**Subject: SP24-128 • Black Rock Coffee • S. Parker Rd. & Stroh Rd. • Parker Pointe F1 AMD 1 L4A – Drive Through Coffee Shop • First Referral • review Comments 02: Response Letter**

The following are responses to comments received from Case Planner, Julia Duncan, with the Town of Parker Planning Department, dated February 4th, 2025, regarding the submittal of a land use application with the Town of Parker.

**Fire Life Safety Comments**

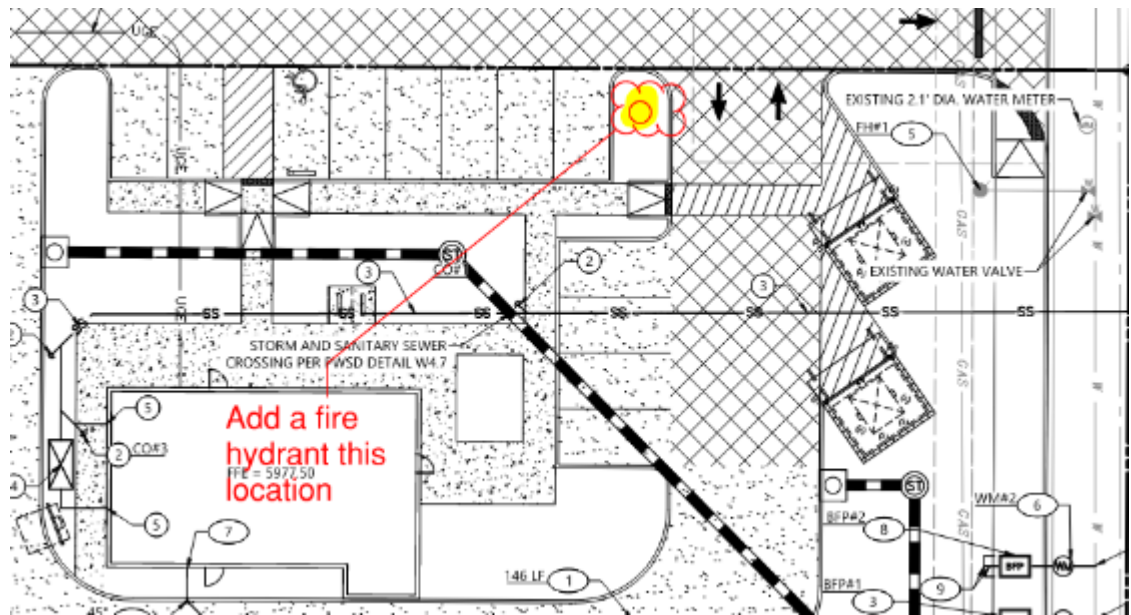
- Noted.
  3. The applicant shall be aware that the access road hydrant distribution was not planned to address the suppression needs for all commercial properties within this subdivision; this site requires the addition of one hydrant (to be located at the s/e corner island of the building... as required per NFPA 24 Section 7.2.3. The hydrant shall be located within 40 feet of the building to be served. A fire hydrant shall be provided and located in the northeast island (see below) and address this issue when resubmitting.

- a.
  - This fire hydrant and associated lines/valves have been added to both the original sheet set and the PWSD sheet set.

**Commentary Figure 503.1.1(2) FIRE DEPARTMENT ACCESS ON TWO SIDE**

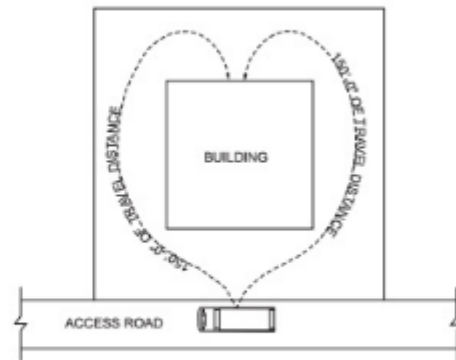
5. Per the requirements of the 2021 IFC Section 503.1.1, approved fire apparatus access roads shall be provided to for every facility such that the requirements of this section extend to within 150 feet of all facility and all portions of all exterior walls of the first story of the building as measured

by an “approved route”. If this cannot be achieved, the fire code official is allowed to increase that distance so long as the building is fully sprinklered per 903 of the 2021 IFC. While it appears that the applicant may be able to meet the requirements of the code, the applicant shall prepare and provide an exhibit that “proves that the access can be met. Please note, hose does not bend at 90 degrees and the applicant’s exhibit shall mimic the exhibit provided in the 2021 IFC Handbook. To aid the applicant with what this looks like, please see the following and address this issue when resubmitting (measurement shall be taken centerline of the access road on the north side of the lot.

- a. ➤ This Fire Hose Proximity Exhibit has been included with this resubmittal.
- 6. In the event that the building needs to be sprinklered, the riser room shall be located in an accessible location (northeast corner of the building) and shall meet the following requirements:

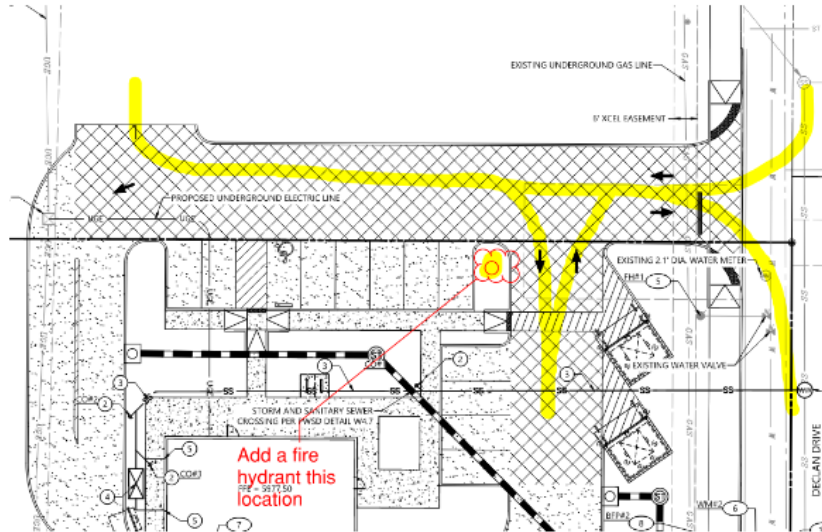
The riser room shall be sized to accommodate the following:

- a. *The underground fire line is not allowed to have domestic tapped off of it*
- b. *The sprinkler riser is allowed to enter no further than 24-inches into the building (and any less than 12-inches into the building).*

- c. *A three-foot clearance shall be provided in front of the riser (with 18" of clearance on either side of the riser).*
- d. *The fire alarm control panel (FACP) is required to be located on an interior wall.*

- e. *A three-foot clearance is required in front of the FACP.*
- f. *Exterior access is required to be provided into the riser room; this access shall be approved.*

- g. *Access into the building shall be provided through the riser room or immediately adjacent to the riser room.*
- h. *While domestic water can be located in the riser room, the domestic cannot be located in any way that conflicts with the access requirements for both the FACP and the sprinkler riser.*

- i. *A sidewalk is required to the riser room and a 5 x 5 pad is required in front of the FDC.*

The applicant shall **provide a floor plan of how the riser room is to be laid out** to avoid conflicts with the site plan once the building review submittal has been made; this project will not be approved without this requirement having been met and approved.

➤ We should not need a riser room as the building does not need to be sprinkled at this time.

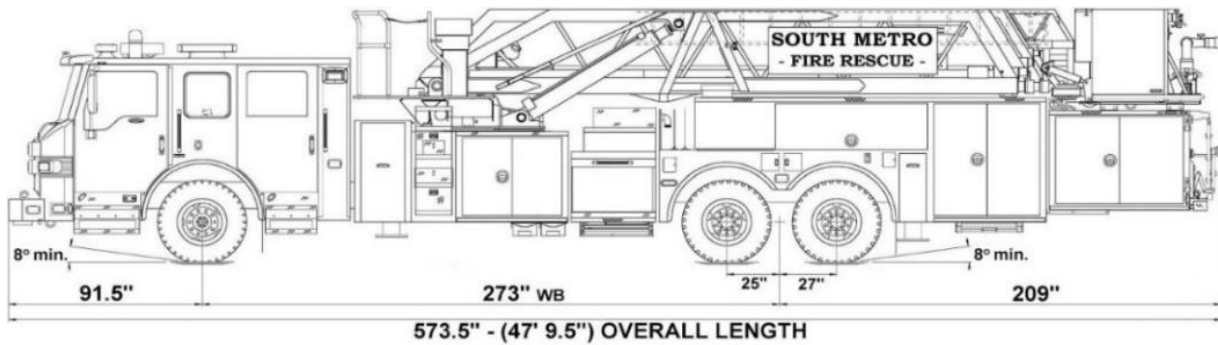
When thrust blocks are used as part of the pipe restraint system, submitted plans for permit shall provide detailed documentation that the thrust blocks satisfy all requirements of 19 NFPA 24: 10.8.2,

including specific thrust block dimensions and mathematical calculations for block dimensions per guidelines provided in Annex A.10.8.2.

➤ Acknowledged
